Notice of Intent

Sundry ID: 2778457

Type of Action: APD Change

**Procedure Description:** OXY USA Inc. respectfully requests approval to amend the subject well(s) AAPD to update the production string cement from 13.2ppg Class H/Poz slurry to a 13.3 Class C/Poz slurry. See the attached drill plan revision summaries and lab test for reference. No surface hole changes or additional disturbance are related to this sundry.

**Laboratory Cement Test Report**  
**MIX 2023-3651 – OXY – HP479 – CHUCK SMITH MDP1 8\_17 FED COM 022H – Production – 13.3ppg**  
**Tail**  
**Service Order: 74499**

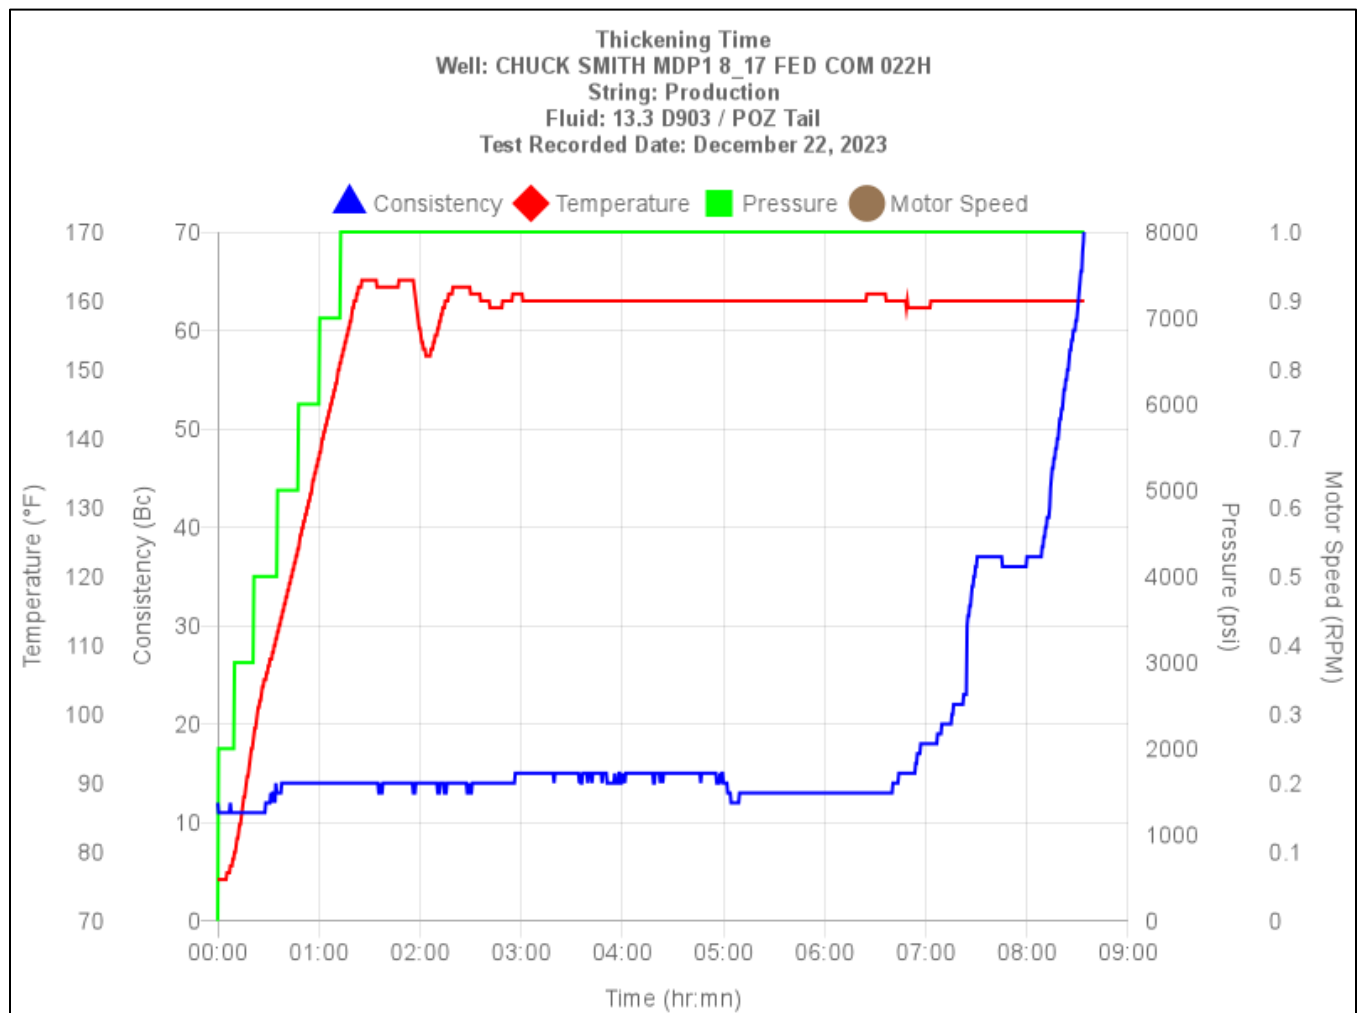
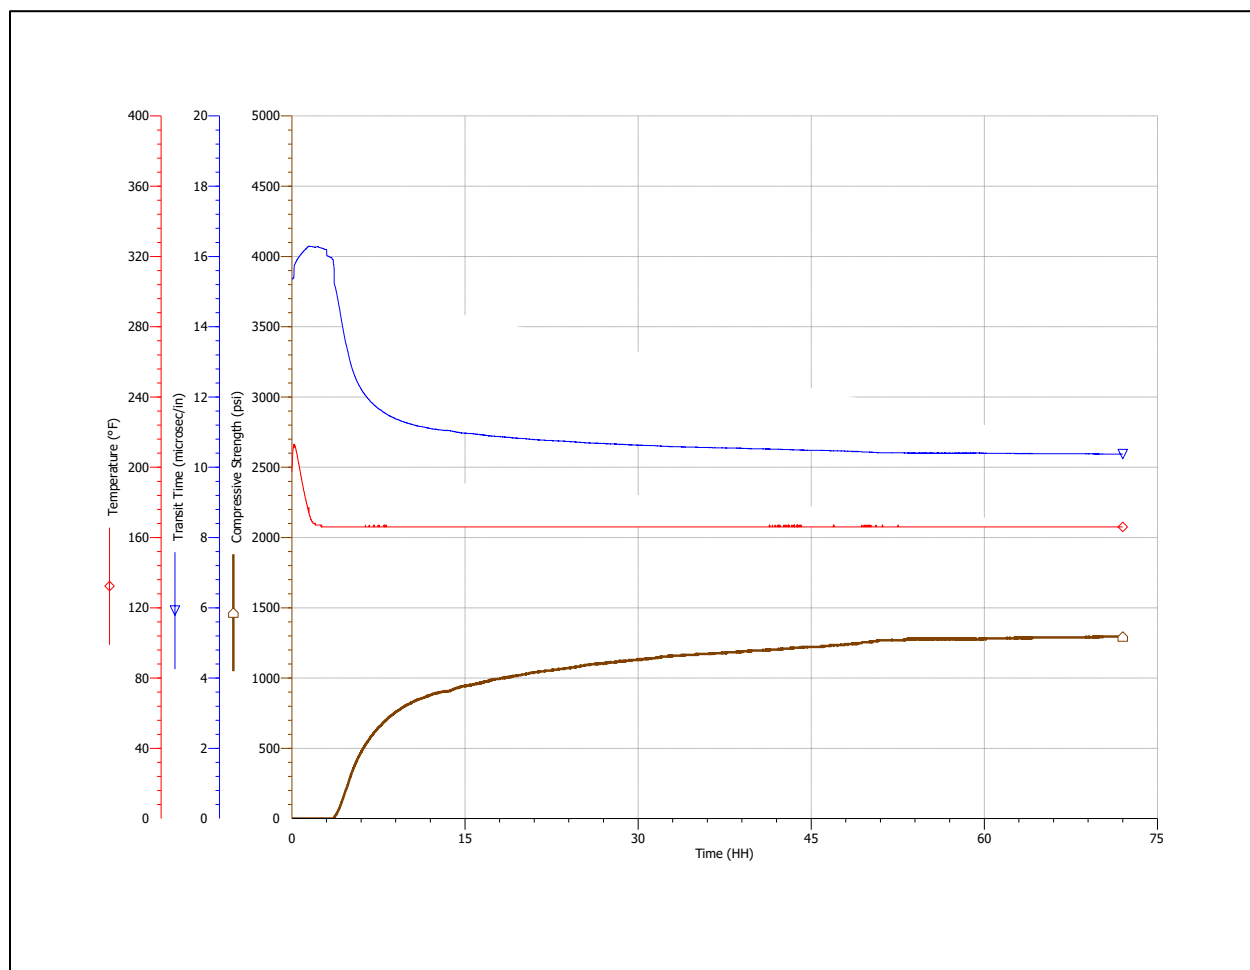
When transitioning from our previous slurry (TXI/SLBD049) due to economic and supply drivers, early attempts were made to utilize API Class H. However, at these densities, (namely < 14.0 ppg) Class H showed rheological concerns resulting in potential mixing issues, higher equivalent circulating densities (ECD's which increased risk of losses), and downhole instability. Densities >14.0 ppg are sufficient for lower Wolfcamp with high mud weights but most shallower benches require 13.2 ppg or less to avoid breaking down formation. Class C / Pozzolan composition mitigated all of these concerns while achieving target fluid properties associated with Thickening Time, sufficient compressive strength development, Free Fluid, Fluid Loss, etc.

Note: When compared to the Class H / Poz system(s), the Class C / Poz slurry achieved earlier (faster) compressive strength development.

Class H / Poz: 500 psi 13:12 hr:mn

Class C / Poz: 500 psi 06:10 hr:mn

Reviewed and is OK.

Please plan on doing batch sundries for the wells these apply to. On the sundry please attach a cement properties summary/ spec sheet as well as an additives list.
